CHANGE ORDER CERTIFICATION

Change Order Number:
CO-01

District & Building Name Yonkers Public Schools - Yonkers Middle High School

Project Description Reconstruction of Portions of the Building

MSK-2

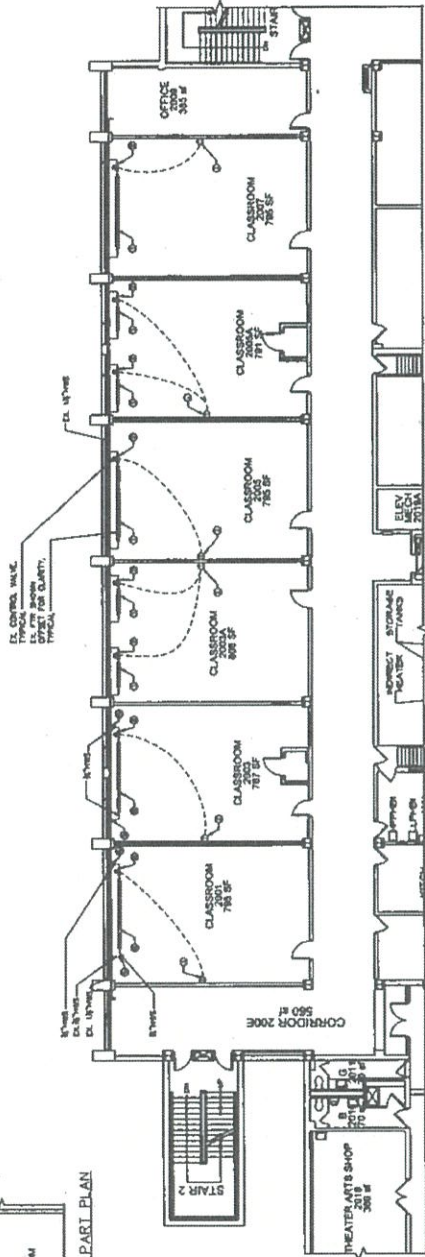
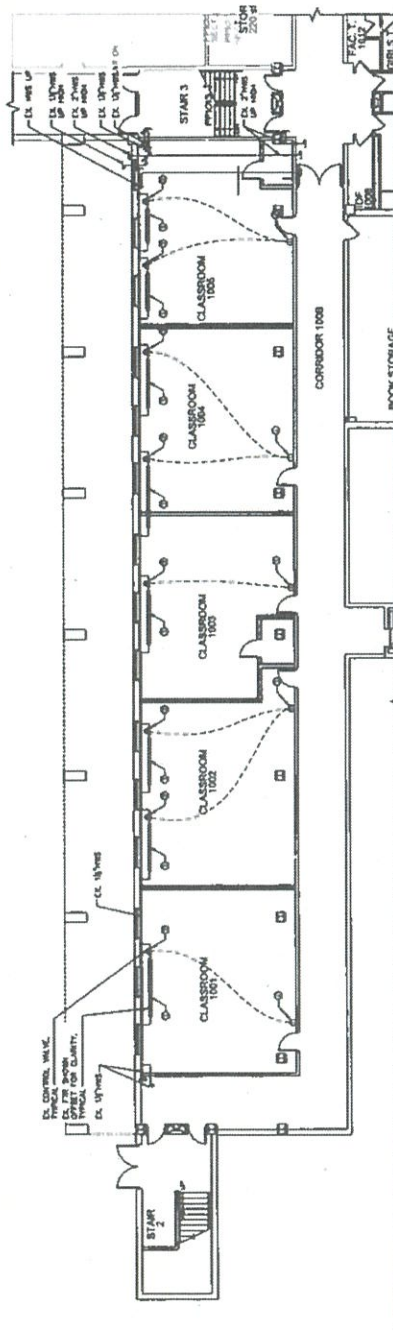
Description	Qty / Hours	Project	
		P.O. No.	Yonkers MHS
		Rate	Total
Mechanical Trash & Storage Room Sketch MSK-1		0.00	0.00
EMF Controls - see attached		4,600.00	4,600.00
PRSM - see attached		2,073.94	2,073.94
Overhead & Profit 5%		333.69	333.69
Bond 2%		140.15	140.15
		Subtotal	\$7,147.78
		Sales Tax (0.0%)	\$0.00
		Total	\$7,147.78

Line#	Item	Description	Qty	Rate	Total
1	Mechanical Jobs	Fabricate & Install Ductwork to the existing Exhaust Fans for tie ins to the existing Louvers. Install BMS to the Existing Exhaust Fans		1,714.00	1,714.00
2	Mechanical Jobs	All fans are existing. Overhead 10%		171.40	171.40
3	Mechanical Jobs	Profit 10%		188.54	188.54
		Sales Tax		8.375%	0.00
Total					\$2,073.94

I need a price for the work shown on sketch. Louvers are installed already by GC. John Becker is asking for the fans to be tied into BMS system so you need to get a price from EMF and include with your proposal.
